CONSTRUCTION SUMMARY

Grovetrail Developments Inc.

LOT NUMBER	PHASE	HOUSE TYPE	CLOSING DATE
30	1	BELVEDERE Elev A	31-Oct-22

Date Added: 22-Sep-21 Invoice Number: 7514

* 10' ceiling, main floor

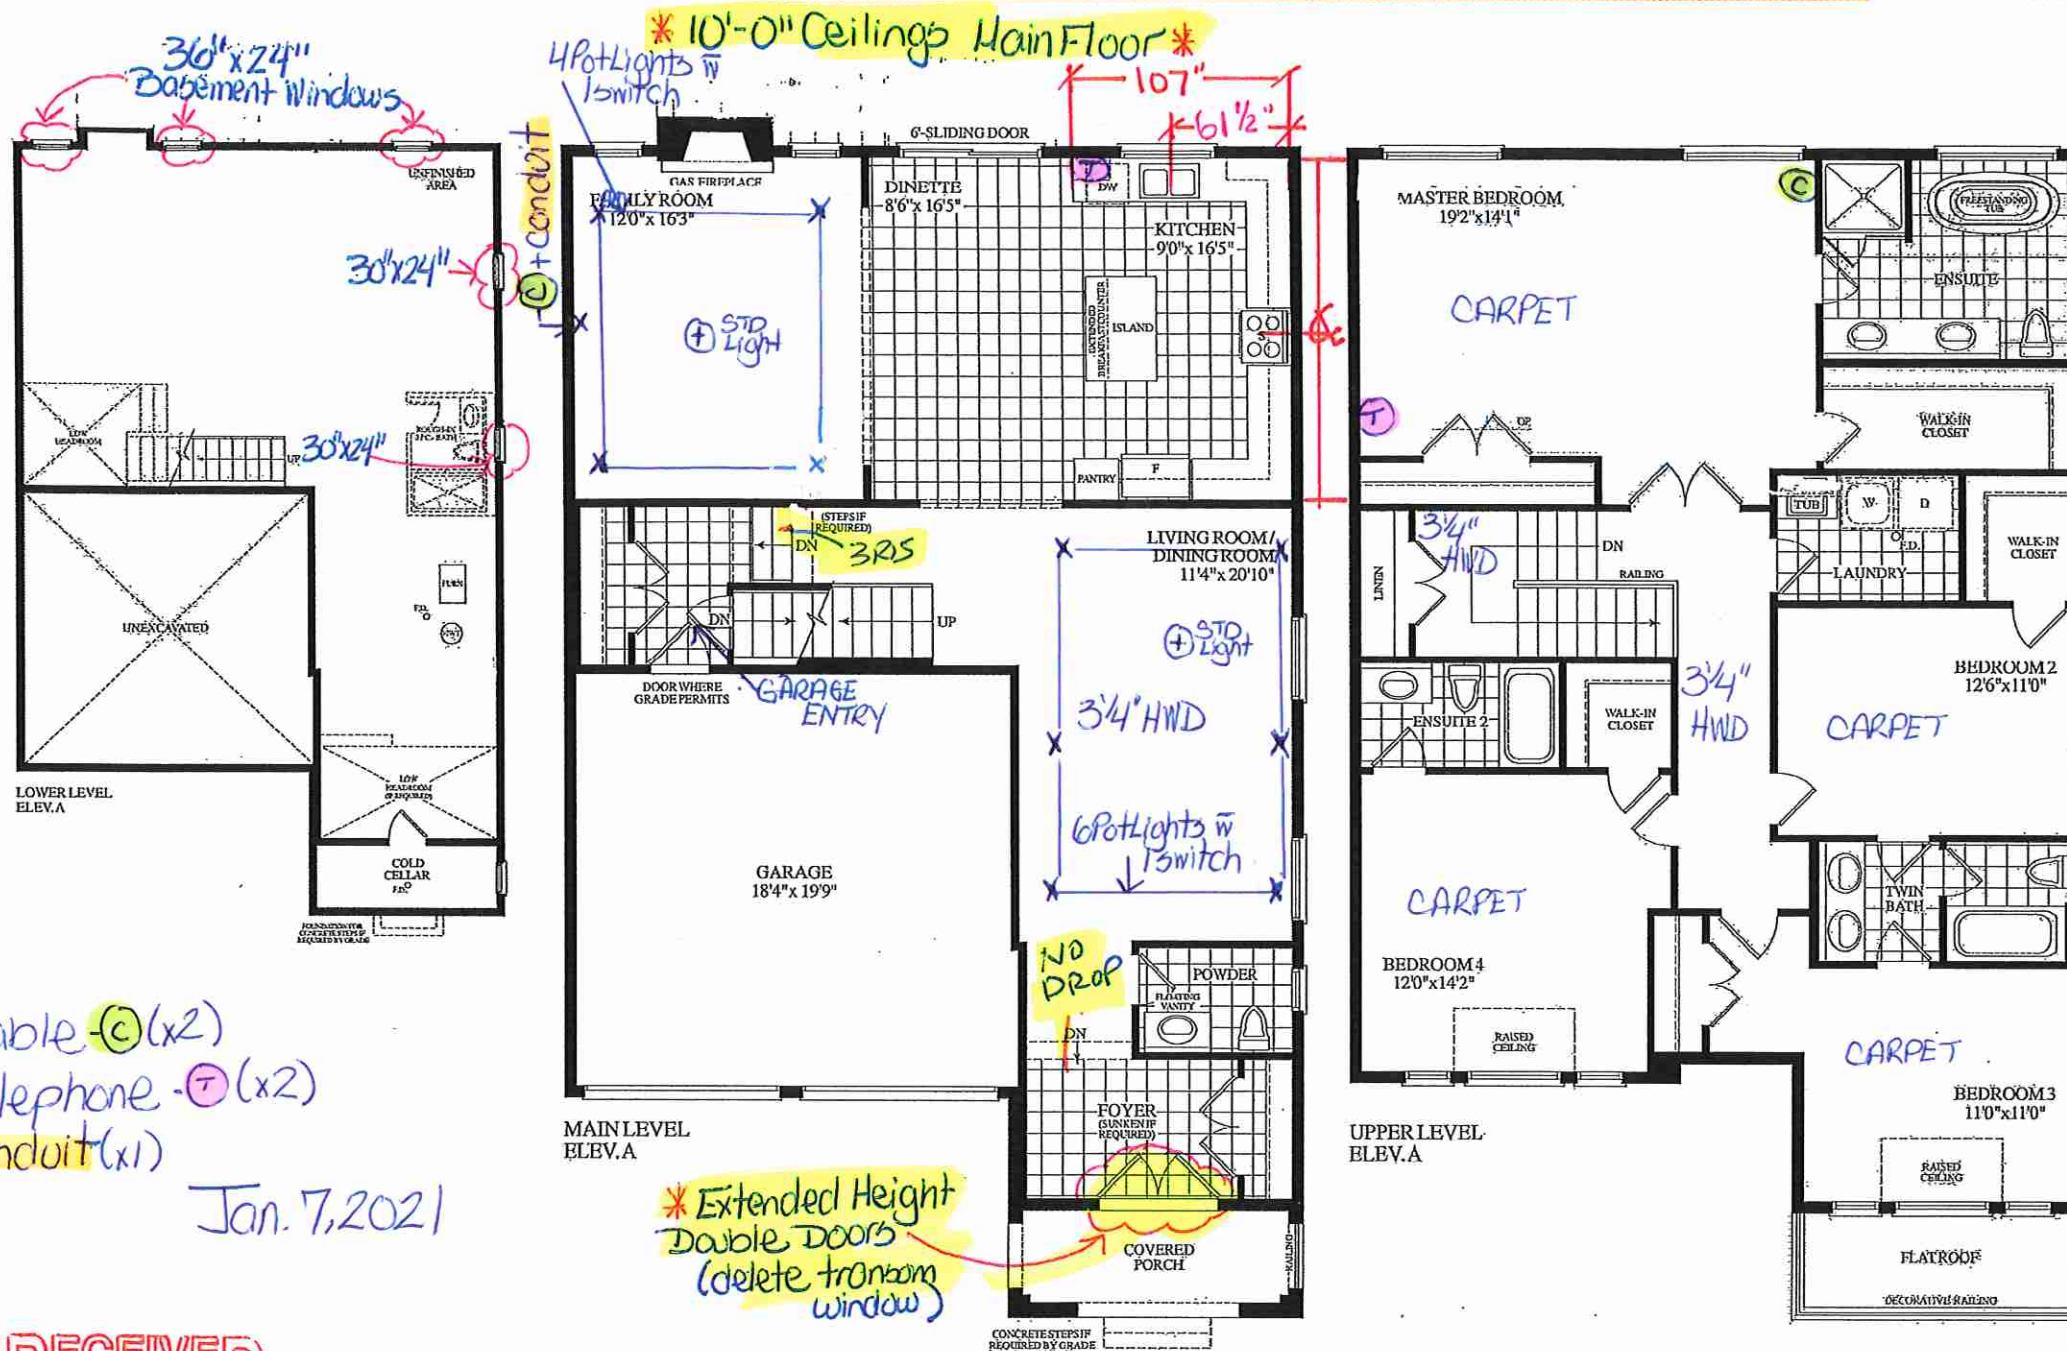
1 - MAIN FLOOR - Install EXTENDED HEIGHT 10'-0" CEILINGS throughout Main Floor, To Include; 8'-0" Interior Doors (Door Height Approx. 92") (Standard Door Only) and Taller Windows, where applicable (See Sketch)
Note:

LOT #30
38-11 ELEV "A"

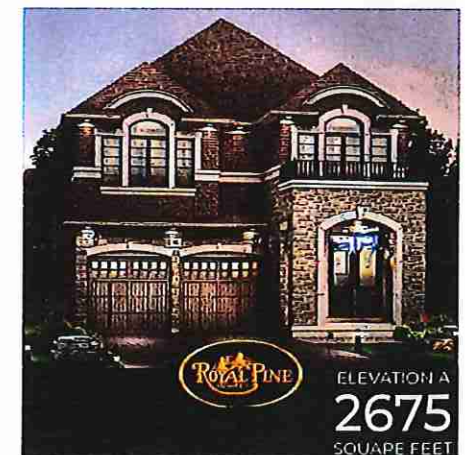
1 - Install Standard CABLE Rough-Ins (x2) and Install Standard TELEPHONE Rough-Ins (x2) (See Sketch) Note:
1 - LIVING ROOM / DINING ROOM - In addition to builders standard ceiling light & switch operated plugs, Install SIX (6) LED POT LIGHTS with ONE (1) Separate Switch - To be installed throughout living/dining room (See Sketch) Note: **TEN (10) Pot Lights with ONE (1) Switch Included in Standard Features and Finishes**
1 - FAMILY ROOM - In addition to builders standard ceiling light, Install FOUR (4) LED POT LIGHTS with ONE (1) Separate Switch (See Sketch) Note: **TEN (10) Pot Lights with ONE (1) Switch Included in Standard Features and Finishes** - Purchaser Paying for Additional Switch Only
1 - KITCHEN & BATHROOMS & LAUNDRY ROOM - SEE QUALITY TOPS & KITCHENS FOR ALL KITCHEN & BATHROOMS & LAUNDRY ROOM UPGRADES / LAYOUTS. (See Attached) Note:
1 - KITCHEN - COUNTERTOP - Install Builders Standard Stone Countertop - EMMERSTONE VANILLA WHITE with STANDARD " A " EDGE PROFILE - To be installed throughout kitchen, where applicable (does not include stone backsplash) (See Sketch) Note:

Cable - (C) (x2)
Telephone - (T) (x2)
Conduit (x1)
